SERVICE DIRECTIVE BULLETIN NO. T-035

1. SUBJECT: Main Rotor Pitch Change Bellcranks Missing Chamfers
2. MODEL: TH-28 and 480 Series
3. EFFECTIVITY: All serial numbers
4. BACKGROUND:

Figure 1. Chamfer on the inboard ear

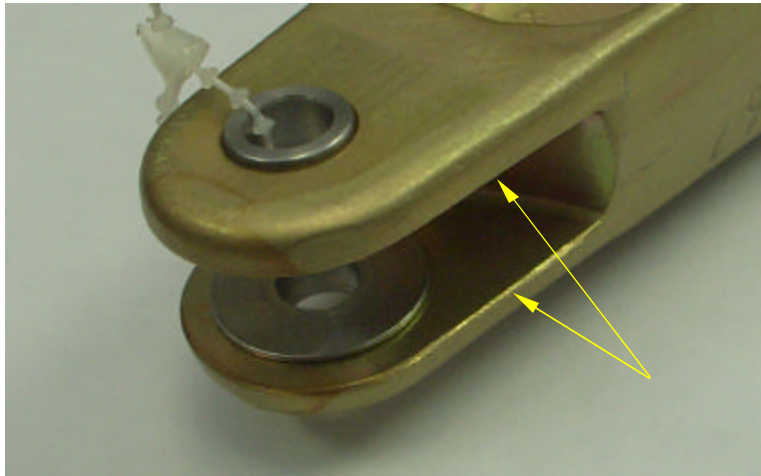
Enstrom has become aware of three (3) Pitch Change Bellcranks (Bellcranks), P/N 28-14207-101, that are missing chamfers on the bottom of the inboard ears. The missing chamfers do not create a Safety of Flight issue; however, the chamfers are required in accordance with (IAW) the FAA Approved Engineering Data.

- A. Using a suitable light source and inspection mirror or by disconnecting the pitch change bellcranks from the main rotor control rods and attachment bracket, inspect the bottom of the inboard ears for a .02" - .04" X 45° / 0.5 mm – 1.0 mm X 45° chamfer (refer to Figure 1). If chamfers are not on the Bellcrank(s), rework the Bellcrank(s) to add the chamfers IAW paragraph 5.2. If the chamfers are on the Bellcranks, reinstall the Bellcranks and return the aircraft to service.

- A. Remove the Pitch Change Bellcranks from the helicopter following the procedures in the TH-28/480 Series Maintenance Manual.
- B. Using a small file or other suitable device, add a .02" - .04" X 45° / 0.5 mm – 1.0 mm X 45° chamfer to both sides of the bottom inboard ear (refer to Figure 1). Apply a protective coating of epoxy primer (Desoto #593 X 300 or equivalent) to the reworked area.
- C. Reinstall the Pitch Change Bellcranks following the procedures in the TH-28/480 Series Maintenance Manual and return the aircraft to service.

Figure 2. Dimensional data for chamfer application

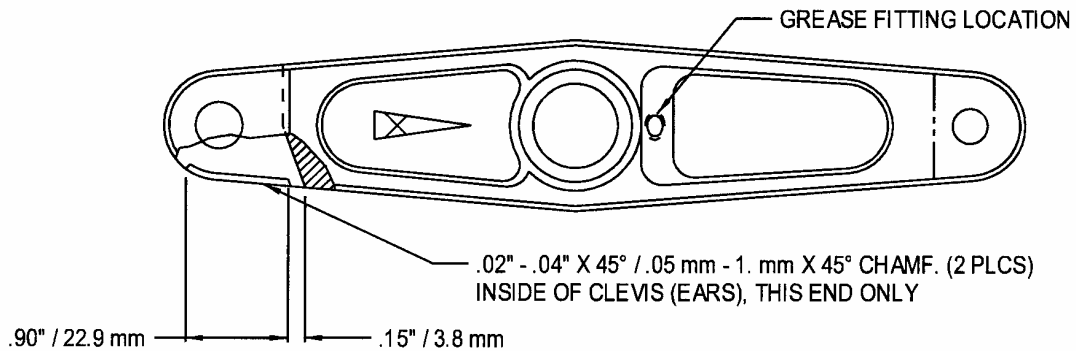
NOTE: BLEND ENDS OF CHAMFER INTO ADJACENT MATERIAL
